212, 220, 222 Steeles Avenue West – OFFICIAL PLAN AND ZONING BY-LAW AMENDMENT

Vaughan Council Committee of the Whole – May 30, 2023

Submission – SpringFarm Ratepayers Association

Figure 2: Site Plan and Landscape Plan, *Planning Justification Report*, p. 41

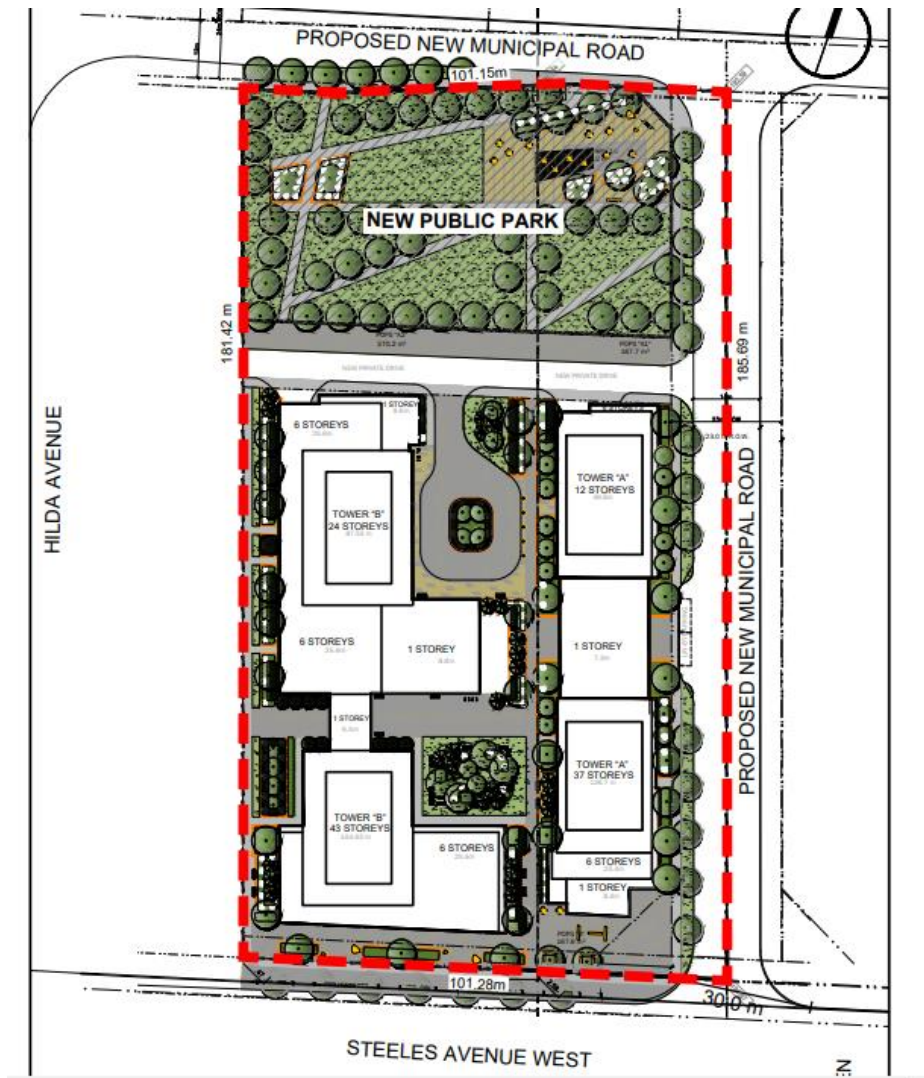
What is less clear is how this vitally necessary park space will be designed and animated. The Secondary Plan’s designated Linear Park provides an excellent opportunity for community engagement and design to make it usable and enjoyable year-round. One possible urban model for a linear park is the David Crombie Park in downtown Toronto in the St. Lawrence Neighbourhood. We understand that the City’s Active Together Management Plan (ATMP) is being revised, but that should not stop the early-stage engagement with local residents to design the linear park, including this section. However, given the City’s deliberate exclusion of resident needs and participation in the March 2022 revision to the Secondary Plan, we need firm guarantees from the City for our involvement in these studies.

We have additional concerns with the Linear Park’s safety for pedestrians and other users, who will have to safety cross several north-south internal roads to access other portions of the Linear Park. At a minimum, high-visibility lighting and traffic calming measures must be installed to reduce vehicular traffic speeds on the north-south roads accessing the future Royal Palm extension across the northern boundary of the Secondary Plan area and this site as well.

SFRA also acknowledges and applauds the inclusion of significant POPS lands that allow for greenery and permeability of the site in the north-south axis from Steeles Avenue West to the Public Park. We would prefer to have a wider POPS space between the two podia along Steeles Avenue West (Phase 1 and Phase 2) to make the interior space more permeable and visibly connected to Steeles Avenue. This can be accomplished by increasing the setback of the eastern side of the six-storey podium in the Phase 2 southernmost tower.

Figure 3: PARCEL 2 GROUND - 6TH FLOORPLANS (Source: *Planning Justification Report*, p. A3-101)

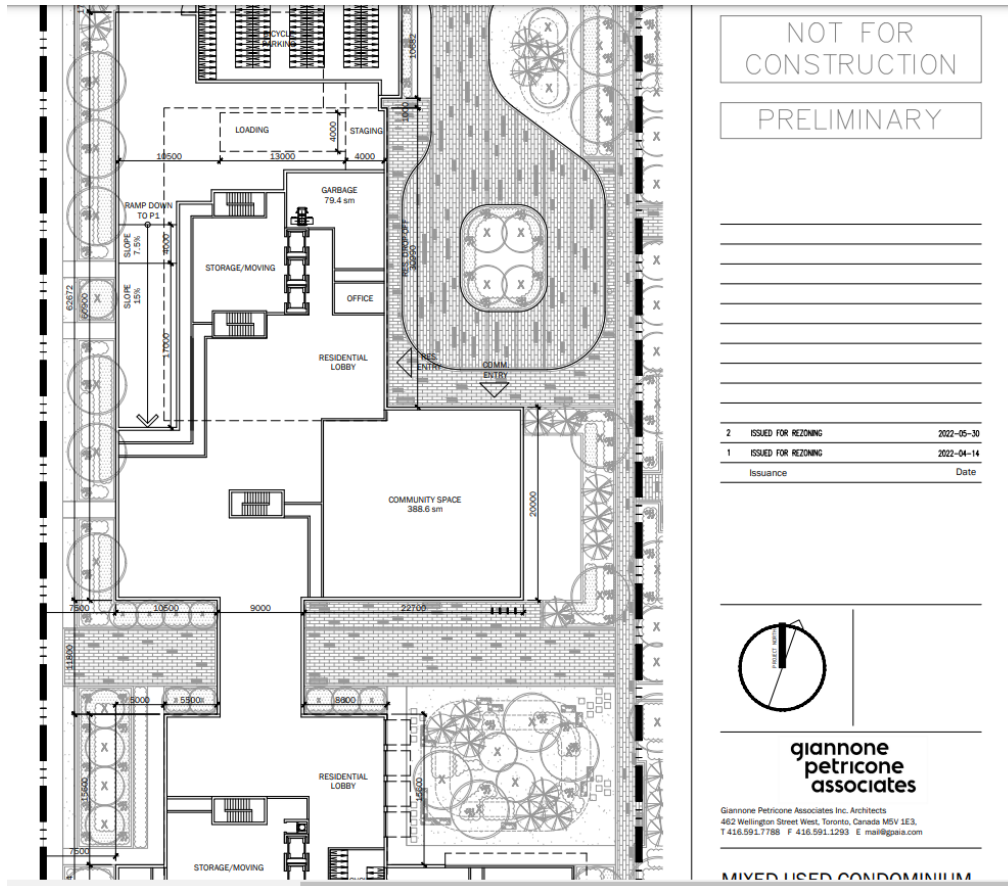
The proposal includes designating approximately 388m² space at grade in the easternmost section of the one-storey portion of Phase 2 (see Figure 3). The site provides driveway access to this Community space from the north, as well as POPS access from the south.

We applaud the inclusion of this space, with a few caveats that require confirmation or changes:

1. There is no designation indicated for its specific use – for example, a library branch, school, recreation facility, community arts facility, etc. Moreover, the proposal does not indicate how the space will be owned – conveyance to the City for its use determination, funding for its animation and programming, as well as ongoing repairs and maintenance. Having a dedicated space that cannot be used due to inadequate funding is of limited value. We believe that AWIN should financially contribute, on an ongoing basis, to the programming, repairs and maintenance of this indoor multi-purpose and multi-use community space, ideally through an agreement with the City.

2. If this space is intended to be available to the larger adjacent community within a larger catchment area, the City must assume that its users will arrive in a variety of modes, including people with mobility limitations. Since there is no on-street parking being made available, the proponent must guarantee a certain number of Accessible visitor spaces in the site’s underground parking lot for Community Space users who wish to or need to park, in addition to being dropped off or picked up, or expect on-street parking on the North-South road or the Royal Palm extension to the north. These underground spaces should be as close to the elevators near the Community Space.

3. As Phase 2 is scheduled for at least 15 years from now, this means that this Community space will only be constructed and made available to the neighbourhood at that time, with no local benefit for

either the existing or new residents until then. We would prefer to see this Community space allocated within the one-storey podium in Phase 1 between the two towers, which would also allow for better drop-off and pick-up access from the North-South road for those with mobility issues, and for better proximity to Steeles Avenue for users arriving by public transit along Steeles Avenue.
